MP 06_0162 MOD 9 (Revised) - Blocks 5, 6 & 7, Barangaroo Central

Thank you for the opportunity to comment on the revised plans and supporting documents submitted by Infrastructure NSW for MP 06_0162 MOD 9 in response to issues raised by government agencies, the City of Sydney and members of the public on initial release of the MOD 9 application in July 1922.

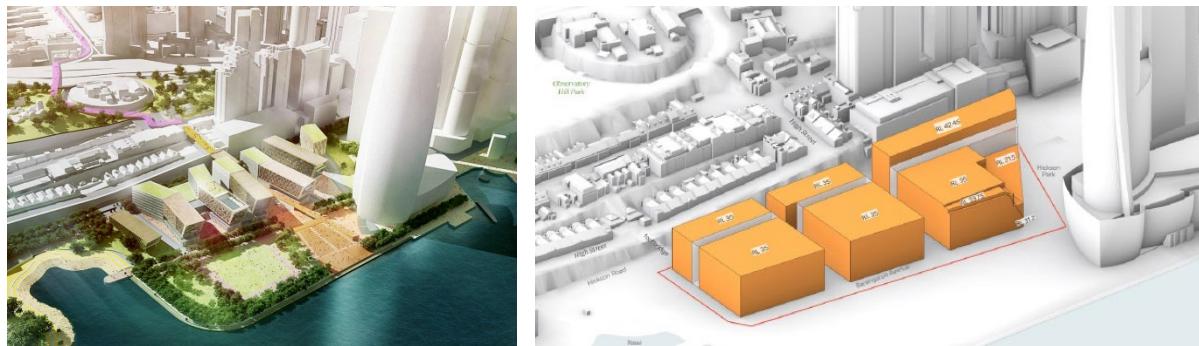
The 'bar code' configuration of Barangaroo Central (approved in 2007), was maintained in MP 06_0162 MOD 2 (approved in February 2009), and formed the basis for the MOD 9 studies undertaken by Skidmore, Owings & Merrill and Andersen Hunter Horne from 2013 to 2019 (Figures 1-3).

The SOM/AHH design team was replaced by Hassell in 2020. The 'bar code' configuration was abandoned in Hassell's scheme for the MOD 9 application lodged with the Department of Planning in July 2022. A massive 'perimeter block' configuration was proposed instead, dominating the Millers Point conservation areas and blocking significant views to and from Observatory Hill.

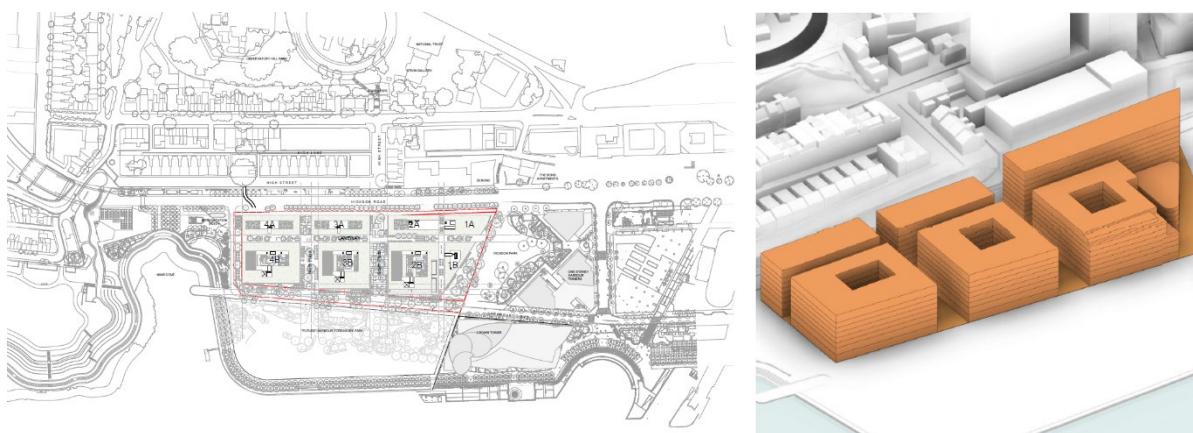
The current 'Response to Submissions' scheme, prepared by SJB Architects, has removed the Chipperfield tower, and reduced other building heights by 2.05 and 3.7 metres. The scheme, however, retains the bulky, view-blocking 'perimeter block' configuration rather than reverting to the 'bar code' configuration. Compared to the currently approved Concept Plan for Blocks 5, 6 & 7, Barangaroo Central (MP 06_01682 MOD 3, approved 11 November 2009, and MOD 8, approved 28 June 2016), the maximum height of Block 5 at RL42.5 is 8.45m higher; Block 6 at RL35m is 6m higher; Block 5 at RL35 remains the same.³

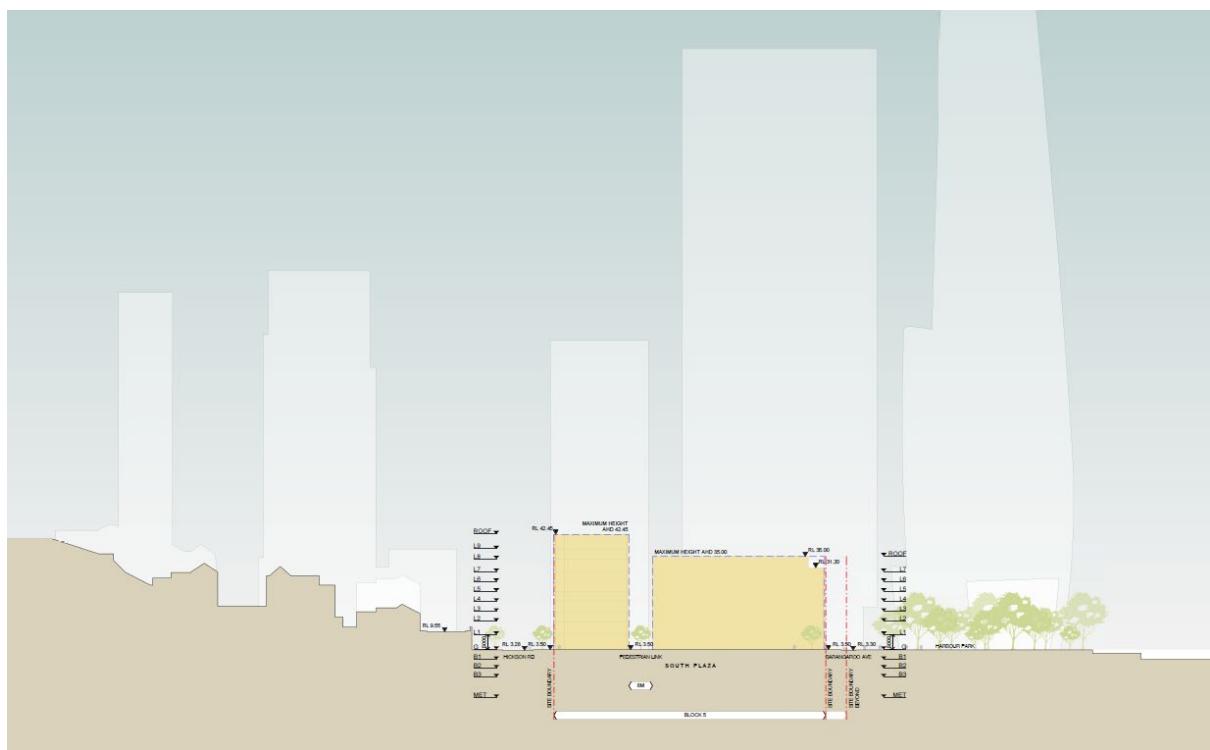
The unacceptable bulk and scale of the 'perimeter block' configuration in relation to the fine scale of the State heritage listed Millers Point conservation areas is graphically shown in the 3D view of the SJB MOD 9 (Revised) Reference Scheme (Figure 7) where the impact of walling in the terrace houses of High Street can be clearly seen, and the SJB site sections (Figures 8 & 9) where the impact of the height differential of these long walls of development dominating the High Street terraces and the stepped profile of the Millers Point precinct is all too evident.

In addition, the long walls of development block views to and from the waterfront of this traditional maritime precinct, and views to and from Observatory Hill.
